Old Angler's Cove, Preliminary Plan No. 120170290

Staff Recommendation: *Approval with conditions*

PRELIMINARY PLAN NO. 120170290: Staff recommends approval of the Preliminary Plan subject to the following conditions:

Figure 4 – Variance Trees and Site Constraints

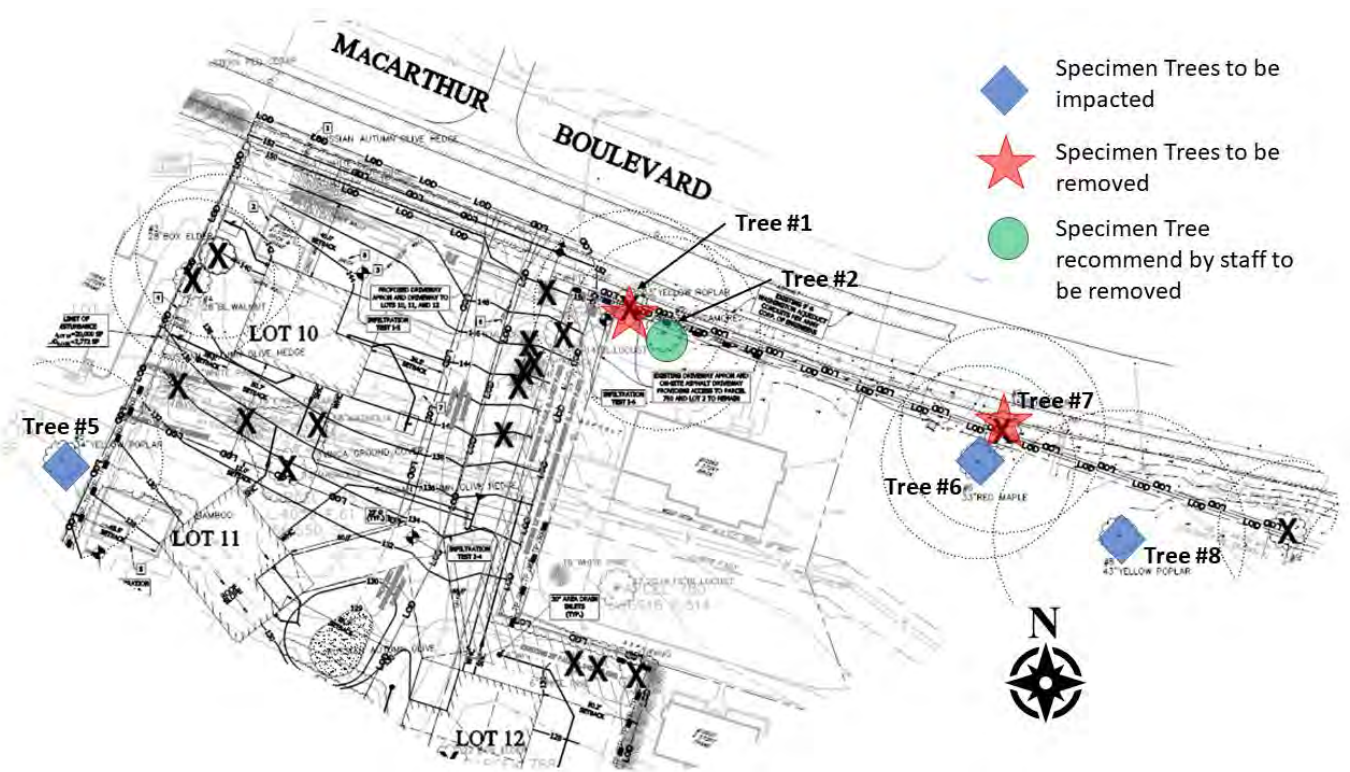
Per Section 22A-21(a), an applicant may request a variance from Chapter 22A if the applicant can demonstrate that enforcement of Chapter 22A would result in an unwarranted hardship. In this case, the Applicant is faced with having to remove three (3) specimen trees and impacting three (3) others. The three trees to be removed and the three trees being impacted are located off-site. (Figure 4).

Staff has determined that the impacts to these trees for the construction on these proposed lots and for the installation of the 8" water main are unavoidable. The proposed lots range in size from 20,000 square feet up to 33,825 square feet. Lot 11 is a 27,435 square foot pipe-stem lot that is encumbered with a Category I Conservation Easement at the rear of the property. This results in the buildable area being constrained on this lot and pushing a portion of the construction area into the CRZ of Tree #5.

The two specimen trees proposed to be removed (Tree #1 and #7), the one specimen tree that Staff recommends for removal (Tree #2) and the three additional trees proposed to be impacted lie within the LOD of the required 8" water main. The location of this water main cannot be shifted to prevent the removal of Trees #1 and #7, and reduce the impacts to Trees #2, #6 and #8 since there is a U.S. Corp of Engineers (USCOE) easement containing aqueduct conduits within MacArthur Blvd. which limits the installation of the 8" water main to the extreme edge of right-of-way of MacArthur Blvd.

PRELIMINARY PLAN

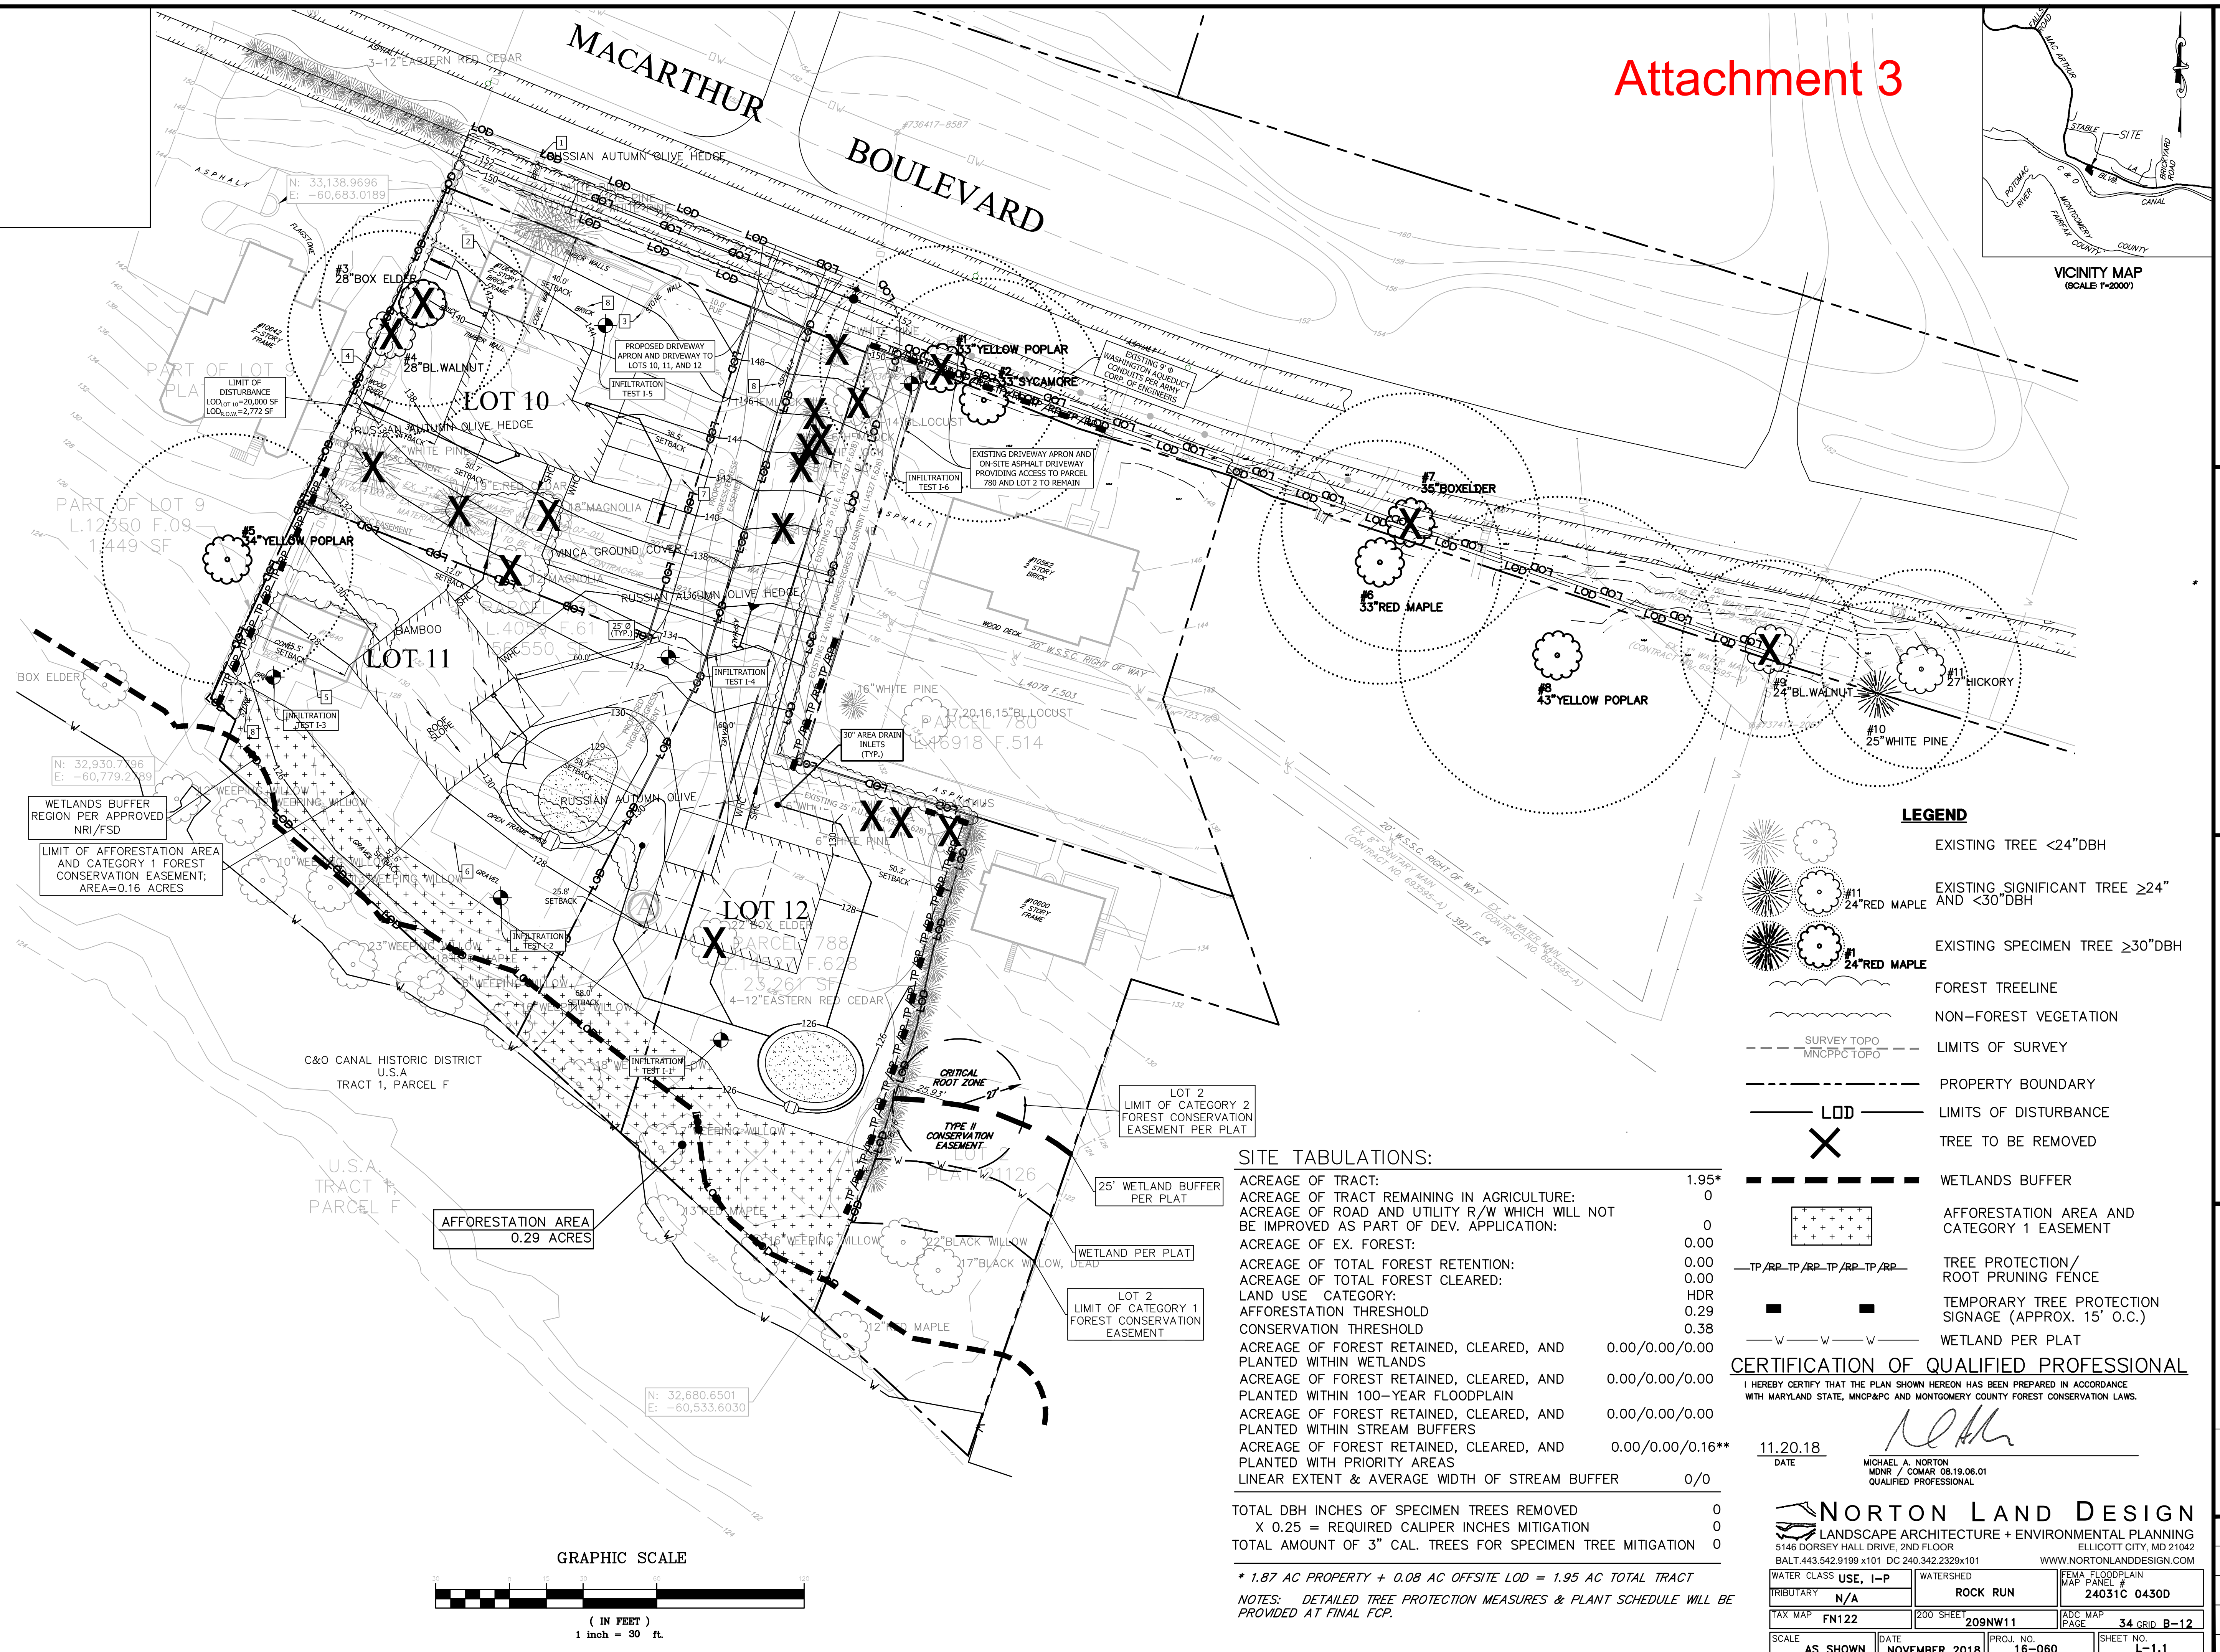
15. Prior to submittal of the Certified Preliminary Plan, the Applicant must make the following change:
 - a. Modify the data table to accurately reflect the correct building heights based on lot size required by the Zoning Ordinance and the correct maximum heights allowed for each lot.

We have completed our review of the preliminary plan uploaded to eplans on November 26, 2018. A previous version of this plan was reviewed by the Development Review Committee at its meeting on October 31, 2017. We recommend approval of the plan subject to the following comments:

1. The applicant must build the proposed shared use path on MacArthur Boulevard per the MacArthur Boulevard Bikeway Improvement Project – Segment 1(CIP 509337). The applicant must provide an engineer's cost estimate for the ten-foot, asphalt shared use path that will include contingencies and be approved by and paid to MCDOT prior to the issuance of the right-of-way permit. If the County has already completed the project or decides not to implement the project, the applicant will continue to make the payment prior to issuance of the first building permit. Coordinate with Ms. Angel Cheng of our Division of Transportation Engineering. Ms. Cheng can be contacted at 240-777-7274 or angel.cheng@montgomerycountymd.gov.

6. Provide a ten (10) foot wide Public Utility Easement (PUE) along the MacArthur Boulevard street frontage.
7. The sight distance evaluation is acceptable. An approved copy of the certification is included with this letter.
